Accommodating Future Expansion Main Ring/Transport Line Crossing

Technical Board Meeting

30 November 2015

Option 1 – Crossing at Main Ring Elevation

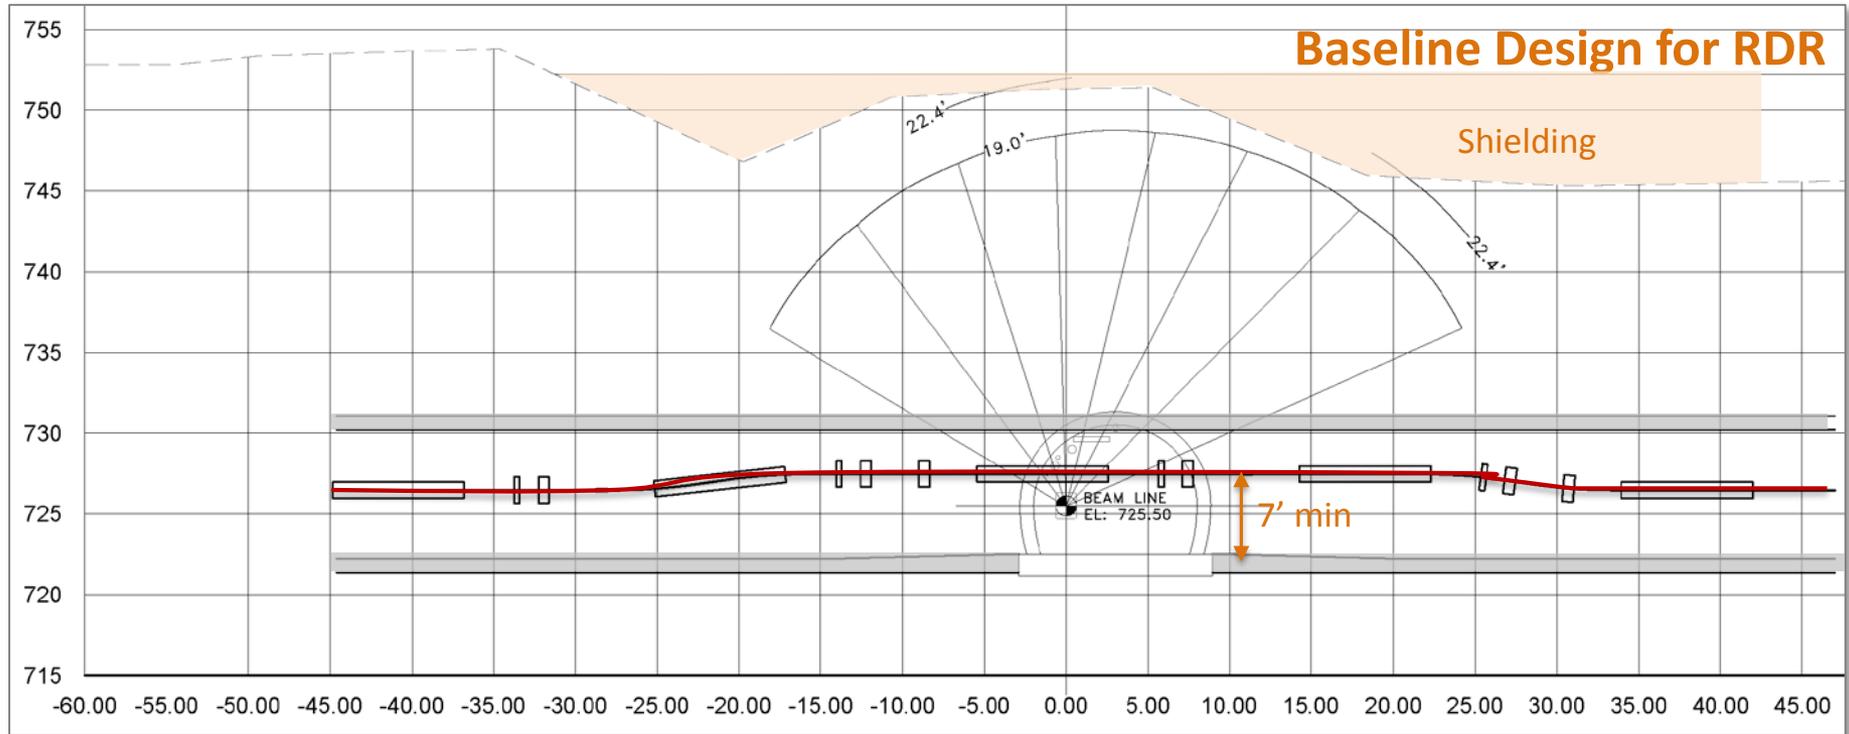
- **Concern #4** – Crossing at Main Ring Elevation (Option 1) – Magnet movers in the Main Ring require an 8 foot (9 ft?) clearance. Access through this area would be a major concern for enclosure operations, beamline coordinators, and support technicians.

Option 2 – Crossing Above Main Ring

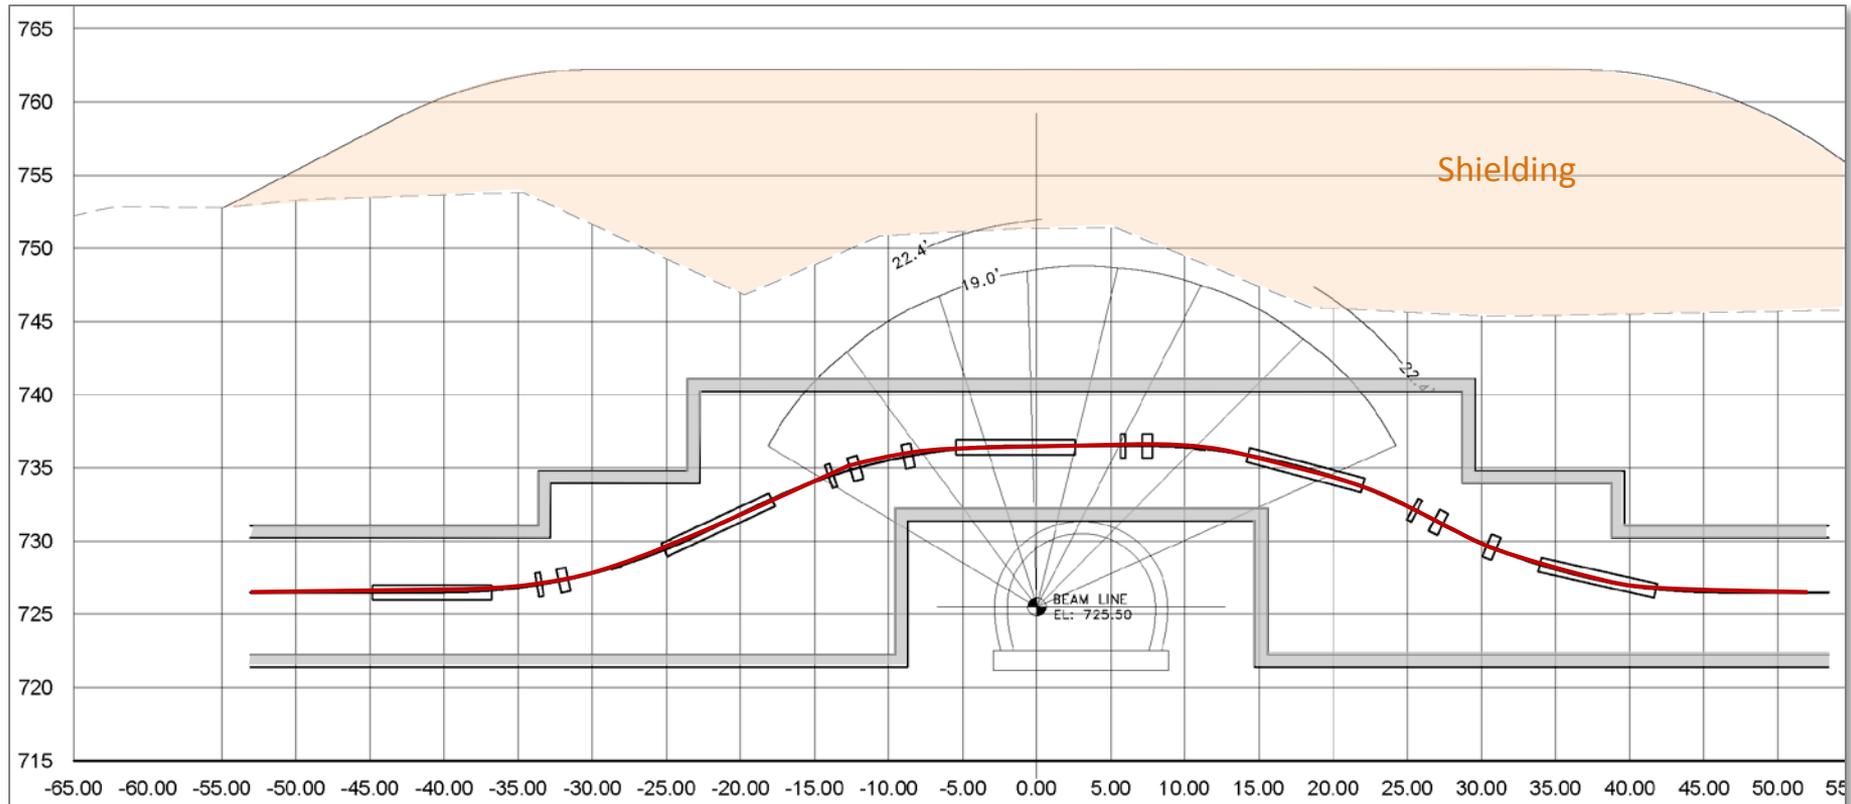
- **Concern #5** – Crossing above/below Main Ring (Option 2 or Option 3) would create beam intensity limitations. Any future upgrades of beam intensities may require replacing dipole magnets and/or utility upgrades. This problem was encountered during construction of Tevatron C0 and D0 collision halls.

- **Concern #6** – Crossing above/below Main Ring will create significant magnet installation and support stand challenges. A solid budget estimate for engineering and CAD drafting (EDIA) would be needed. This is not an impossible issue. However, a challenge nonetheless that must be considered. – **Sloped tunnel @ 8% grade might help.**

- **Concern #7** – Crossing above/below Main Ring will result in significantly limited access. PIP-II Transport line (West) would only be accessible from Booster high bay in the AD footprint Cross Gallery. Pip-II Transport line (East) would only be accessible from PIP-II LINAC Center Service Building High Bay. Is this a problem? Probably not. But maybe an inconvenience when bringing heavy, large equipment to the transport enclosure.
